MEETING AGENDA

CITY PLAN COMMISSION Wednesday, February 23, 2022 Work Session 12:30 p.m. Public Hearing: 1:30 p.m.

PP-21-100 Eagles Crossing, Lots1-2, 3X, 4-31, Block 1; Lots 1-44, Block 2; Lots 1-44, Block 3; Lots 1-44, Block 4; Lots 1-9, Block 5; Lots 1-3, 4X, 5-27, 37X, Block 6 (Waiver Request/Conditional Approval): 195 Single-Family Detached Residential Lots, 1 Multi-Family Lot, 1 Gas Well Pad Lot and 5 Private HOA Open Space Lots. Council District 6.

Case: PP-21-100	Remarks Due:
Submitted: 12/8/2021	ZC Hearing:
	Case Status: In Revi
Title: Eagles Crossing

REFERENCE CASE NUMBER: PP-21-100 SHEET 1 OF 1

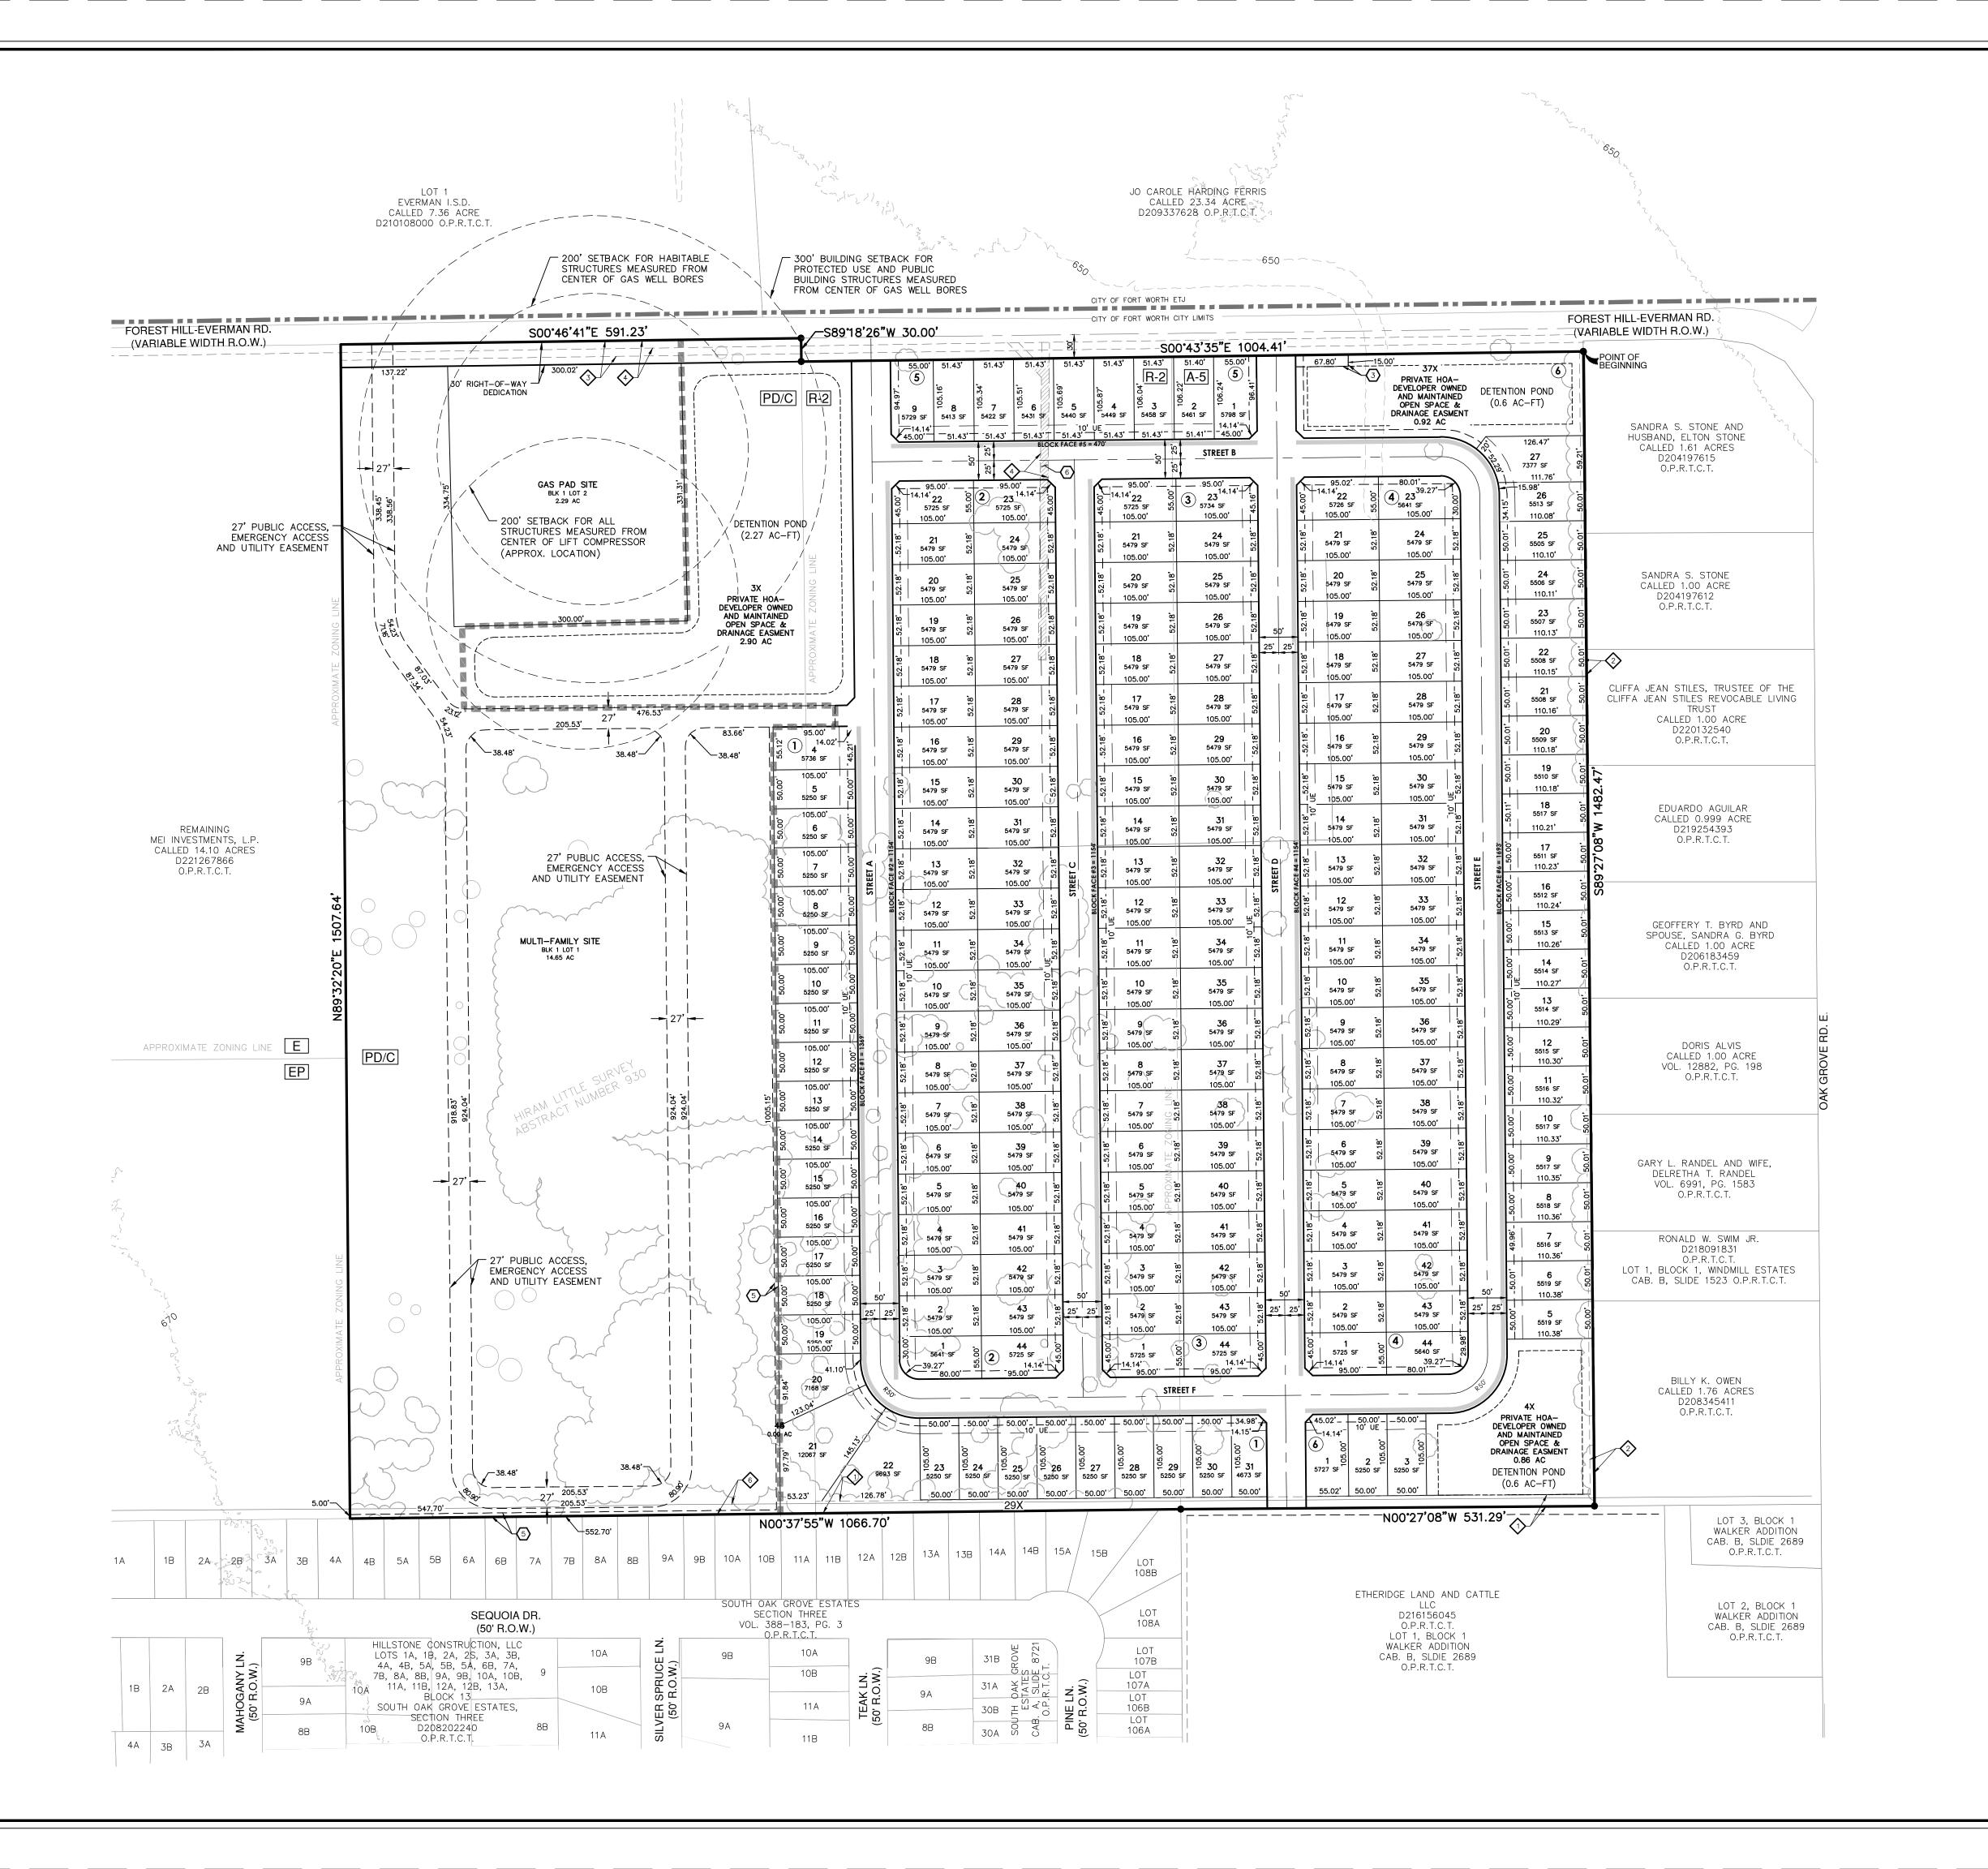
CLEARED 02/09/2022 4. CORRECTION: Gas Well and Lift Compressor Setback:

Show 300' Building Setback radii from each gas well bore and label:

Show 200' Building Setback radii from each gas well bore and label:

b. Show 200' Building Setback radii from the Lift Compressor:

the City's GIS section is asking for verification of the location of the approximate zoning line shown on the plat. The current location indicates the zoning line bisect the Block 1 single family lots and would not conform to the zoning site plan previously approved.

(2) Interconnectivity of Neighborhoods. Fragmented street systems impede emergency access and increase the number and length of individual trips. New residential subdivisions shall be designed to coordinate with existing, proposed and anticipated streets. Local and collector streets shall be extended to the tract boundary to provide future connection with adjoining un-platted lands. Street extension required to the unplatted tract to the north.

Provide a site plan for the multi-family site the corresponds with the 27-foot public/emergency access easement layout.

Revise plat title block to include a description of the lot and block information (ie. Lot 1-9, Block 5).

- 3- P.R.V. note required on plat face; statement shall read as follows:
- "Private P.R.Vs will be required: water pressure exceeds 80 P.S.I".
- 4- Water Extension is required by (CFA) Per City accepted construction plans

Water extension to every proposed lot is required: provide a community facilities agreement for the water improvement as necessary to serve the subject property. No water/sewer in side or back of lots per Subdivision Ordinance.

5- Sewer Extension required by (CFA) - Per City accepted construction plans

Sewer extension to every proposed lot is required: provide a community facilities agreement for the sewer improvement as necessary to serve the subject property. No water/sewer in side or back of lots per Subdivision Ordinance.

FP-21-165

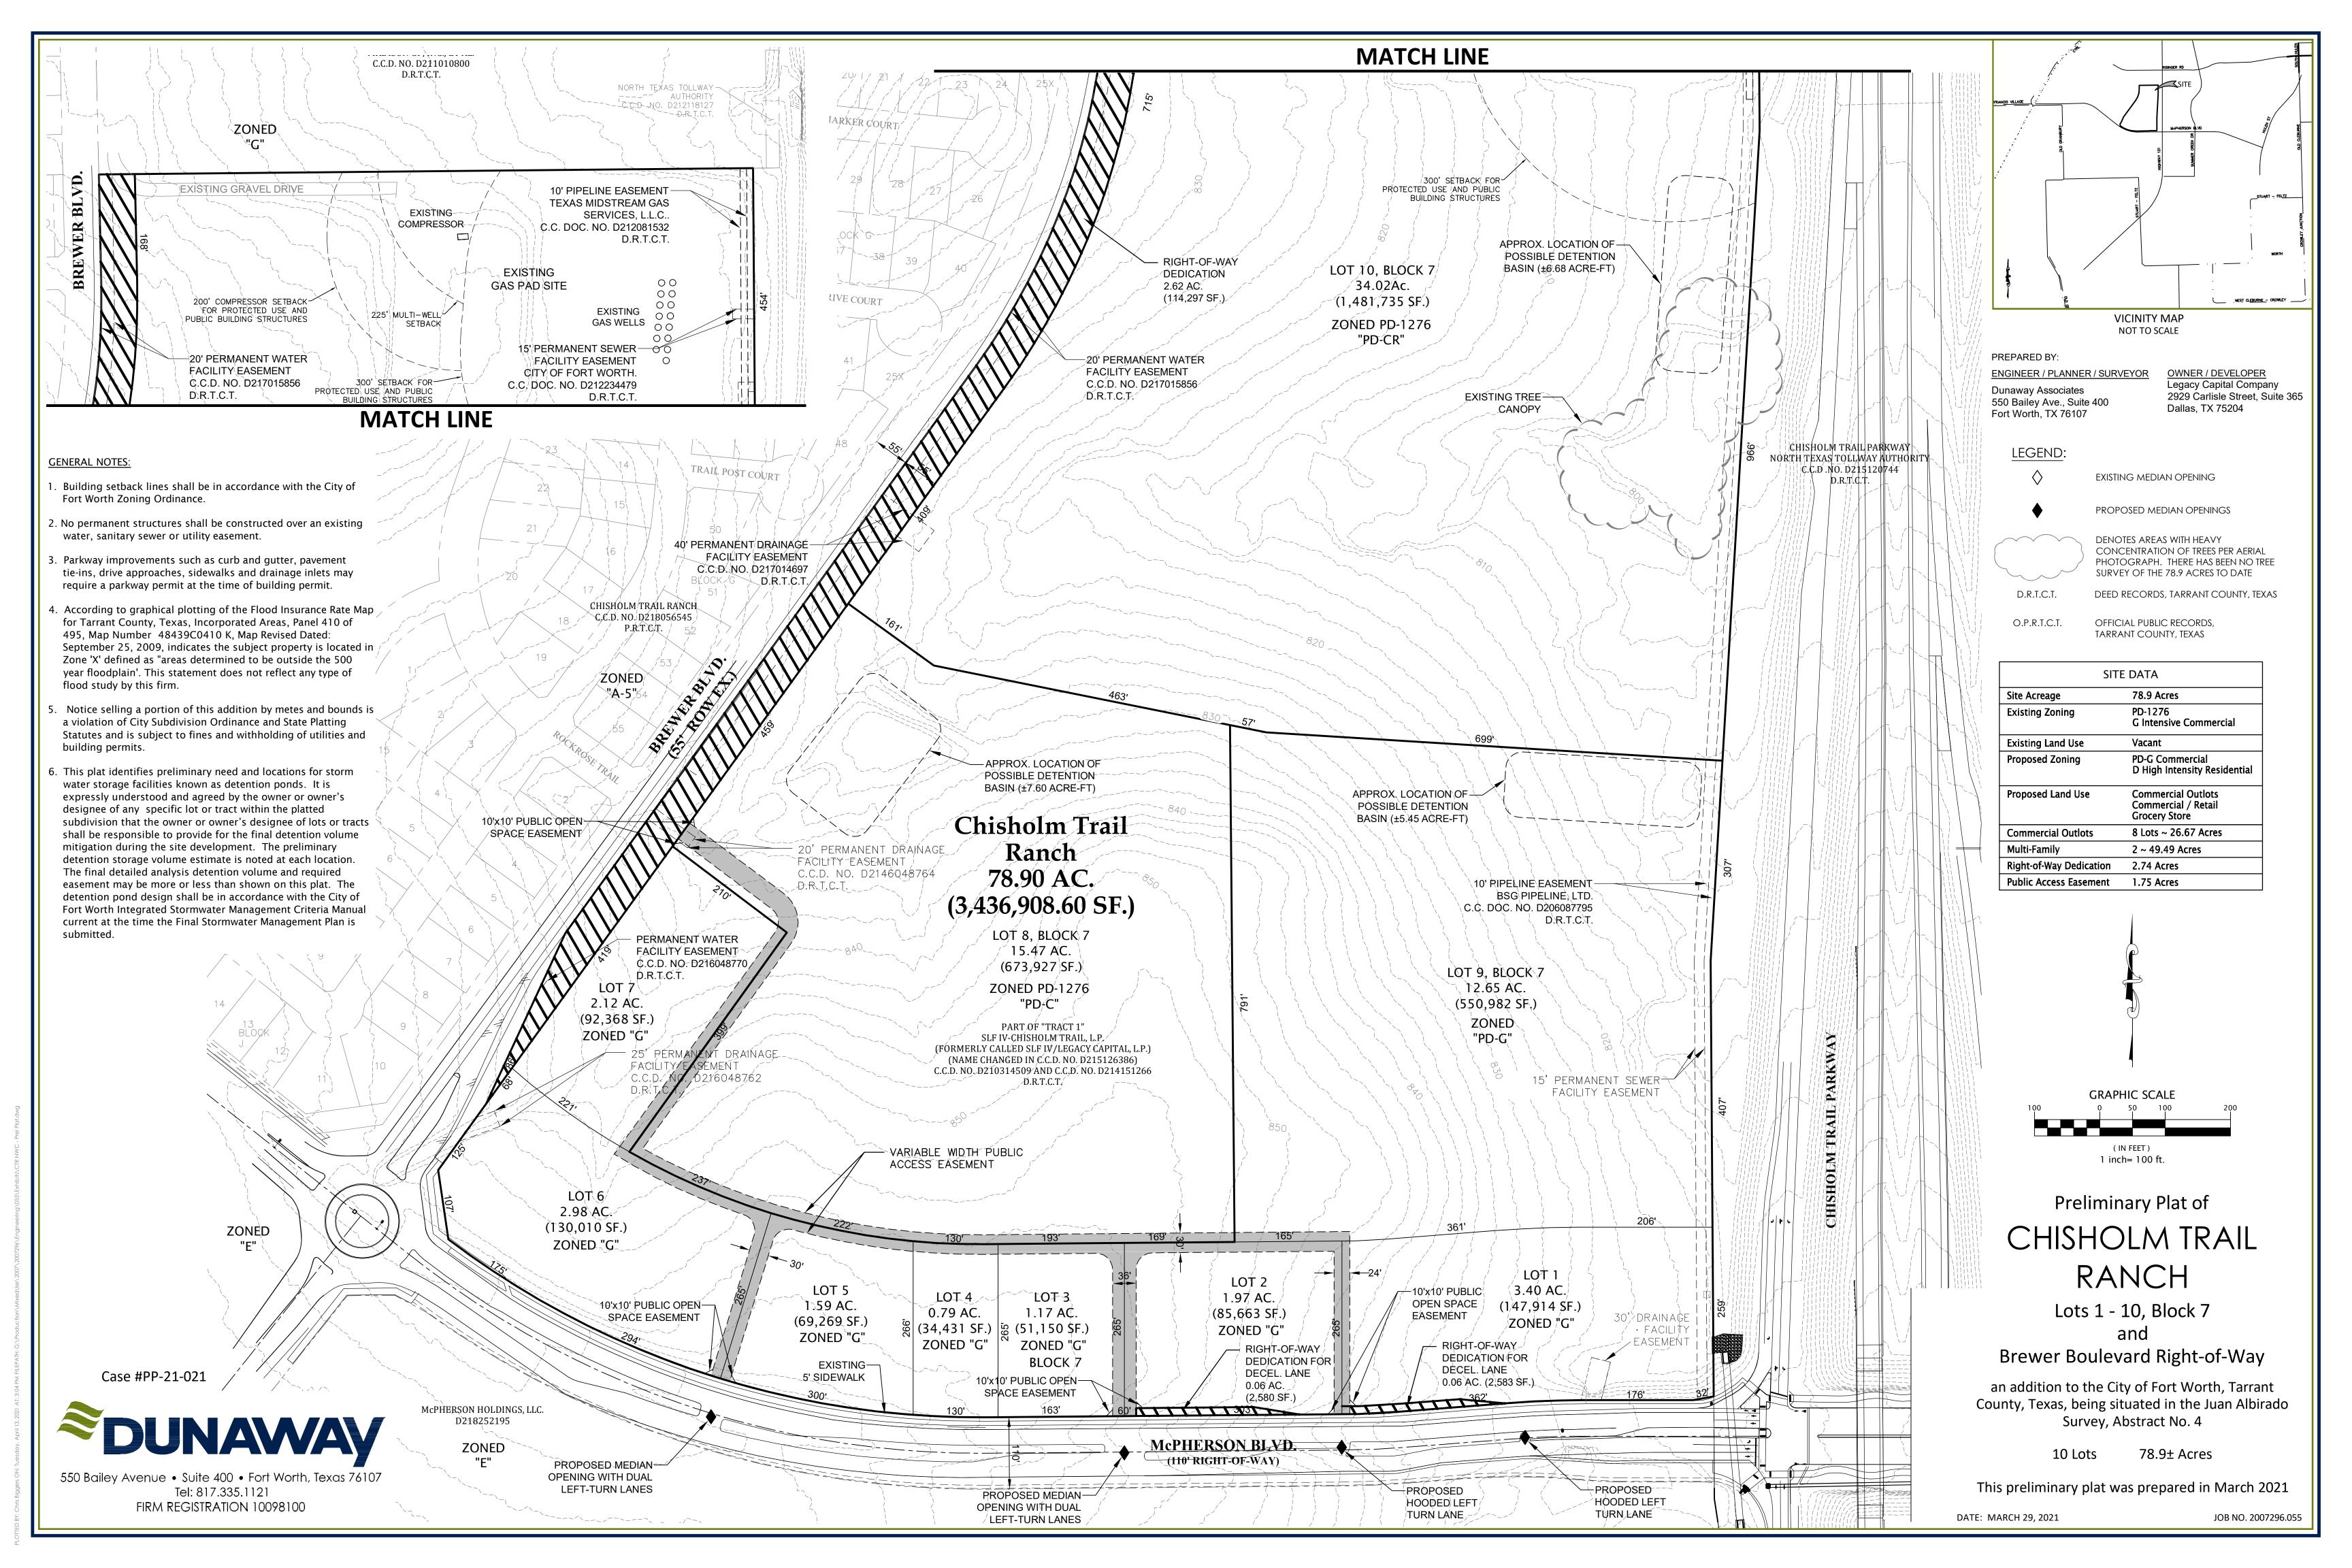
2. Label "Emergency Access/Fire Lane Easement" as Emergency Access Easement and show width. Minimum width is 26'.

- Lynn Jordan 817-392-2309
 Lynn.Jordan@fortworthtexas.gov
 CPC Action February 23, 2022
- 1. (Not Applicable)[SO Section 31-101(c) Two Points of Ingress/Egress: Subdivisions consisting of more than 30 single family units or more than 100 multifamily units can't be recorded without two points of ingress/egress that has been fully constructed and accepted by the City. The public access easement at McPherson has not been recorded and or accepted by the City, please confirm. This will require Conditional Approval by the City Plan Commission.

- 6. (NOT ADDRESSED)(FYI) In the title block change it to Chisholm Trail Ranch to be consistent with the preliminary plat. Chisholm Trail ranch also needs to be updated in the owners dedication.

- 1- HOLD MJP 12/17/2021 Remove PRV note. Pressure is below 80 PSI.
- --- 02/10/2022 Not addressed.
- 2- HOLD MJP 12/17/2021 Water extension is required by CFA.
- --Water Extension required by (CFA) Per City accepted construction plans

- --- 02/10/2022 Not addressed.
- 3- HOLD MJP 12/17/2021 Sewer extension is required by CFA. Extend sewer along the south property line.
- --Sewer Extension required by (CFA) Per City accepted construction plans
